IN REPLY REFER TO
NCPC File No Z C 06-08B

The National Capital Planning Commission, at its meeting on March 4, 2010,
approved the enclosed action on the modification to a Consolidated Planned Unit
Development for the Village at Washington Gateway in the Fort Lincoln Urban
Renewal Area The Staff Recommendation for the project is also enclosed

STAFF RECOMMENDATION^{NI}

**CONSOLIDATED PLANNED UNIT DEVELOPMENT MODIFICATION
AT FORT LINCOLN URBAN RENEWAL AREA (FORT LINCOLN NEW TOWN)
THE VILLAGE AT WASHINGTON GATEWAY
SQUARE 4325 PARCEL 173/145**

FORT LINCOLN – GENERAL LAND USE PLAN

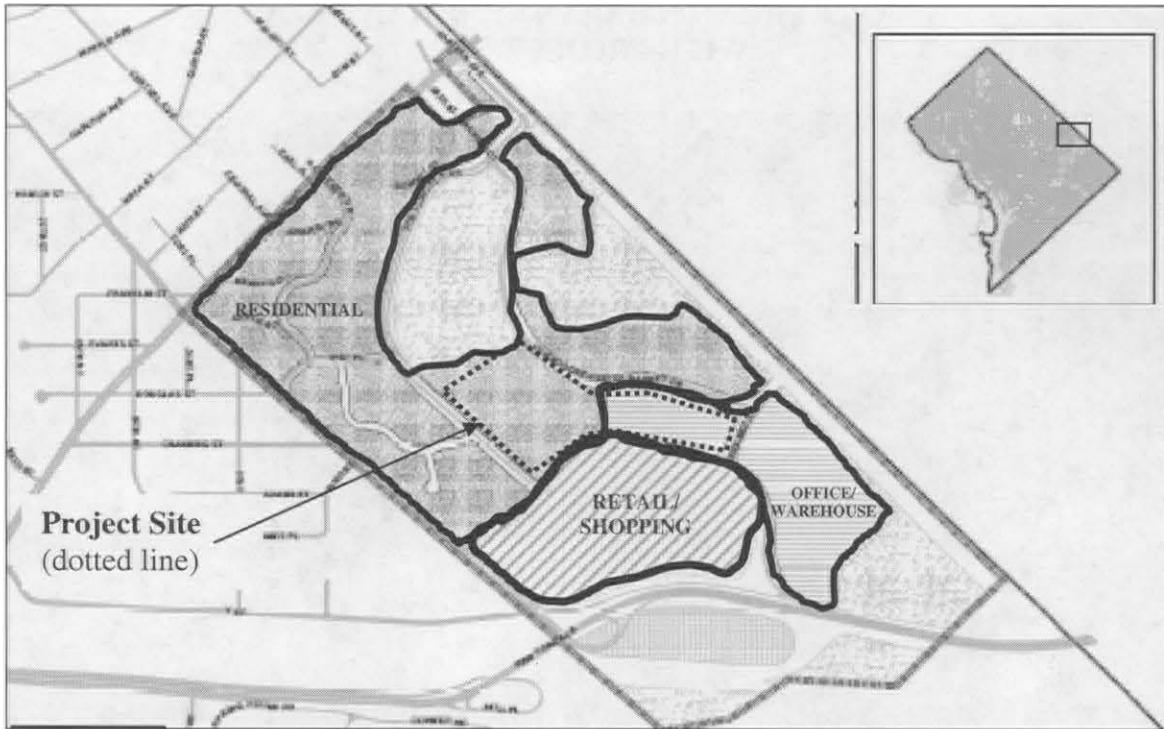
Aspects of the proposal are consistent with the zoning regulations, but not with the PLAN. Those inconsistencies relate to PLAN restrictions of building heights and land use. Building heights up to 90 feet are allowed as matter-of-right in the existing zoning, but the PLAN limits the height of single family townhouses to 40 feet and walkup apartment buildings to 60 feet (PLAN, §513.31). The General Land Use Map of the PLAN identifies a portion of the proposed development site for Office/Warehouse use and Section 532.00 prohibits residential development in this area.

This PUD modification includes single family townhouses ranging from 42 to 47 feet in height, and a portion of the proposed residential development is sited on land reserved for Office/Warehouse use. While staff supports the slightly higher roofline of the townhouses and a modification of the General Land Use Map to allow residential uses on the subject site, the PLAN will require an amendment for the current design to conform. In addition, staff supports the modification of the land use to residential as the residential use would abut the proposed retail center for the site. In addition, staff notes that even after the existing urban renewal plan is modified, a large area of office/warehouse uses will remain as part of the urban renewal plan.
